PINS ref: EN010170

Application by Green Hill Solar Farm Ltd. for an Order granting Development Consent for a proposed solar development on land between Northampton and Wellingborough

CPRE Northamptonshire Written Representation November 2025

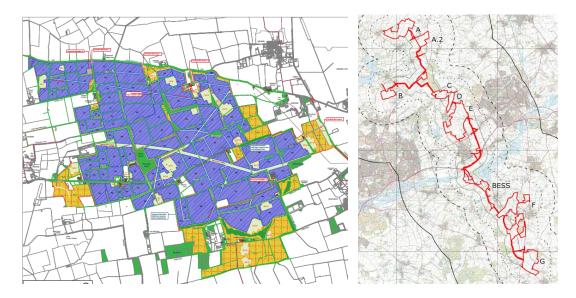
We gain the impression throughout the DCO that it understates impacts that would be felt locally. In our response to the PEIR we expressed concern that **Table 2.1**: **Sensitivity Criteria** in **ES Chapter 2** appears to devalue the level of sensitivity for local impacts. If anything, the sensitivity of the local communities that would have to live with the scheme is much higher than others because they would experience impacts on a daily basis. We recognise that the Examining Authority may ultimately judge that national needs override the impacts on local communities, but it is vital that such a judgement should be made in the knowledge of the true level of impacts that the local community are expected to accept.
